<p>APPROVED BY:</p> <p>D-872</p>	<p>APPROVALS</p> <table border="1"> <tr> <th>NAME</th> <th>DATE</th> <th>SCALE</th> </tr> <tr> <td> </td> <td> </td> <td> </td> </tr> </table>	NAME	DATE	SCALE				<p>INSPECTED BY E.M.W.D.: DEAN EARNISH</p>	<p>EASTERN MUNICIPAL WATER DISTRICT RIVERSIDE COUNTY, CALIFORNIA 3.2 MG MANZANTA I RESERVOIR CHAIN LINK FENCE DETAILS PER EMWD STD D-872</p> <p>FILED DATE: 10/7/03 FILE NAME: P:\001004\DWG\PL14</p>	<p>LD SA 41 V.D. 97-254 C.D. 65776 COORD. 81812 SH. 270-27 1-2 7-3778</p>
NAME	DATE	SCALE

**SECTION 02444
CHAIN LINK FENCING**

WALK GATE N. I. C.

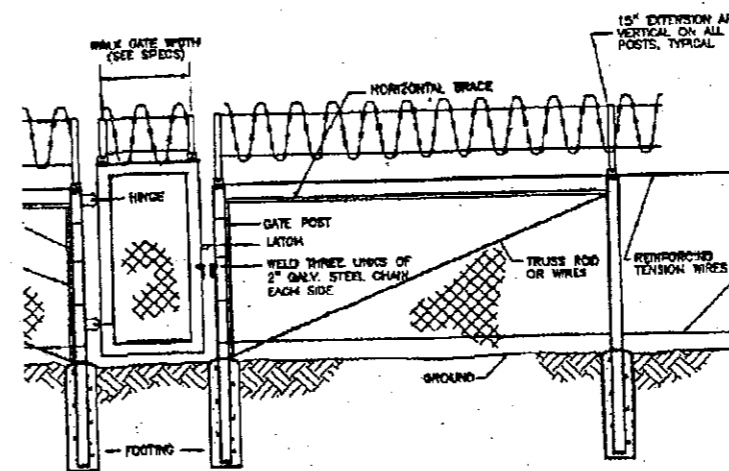
OK BAR 0 OUTSIDE
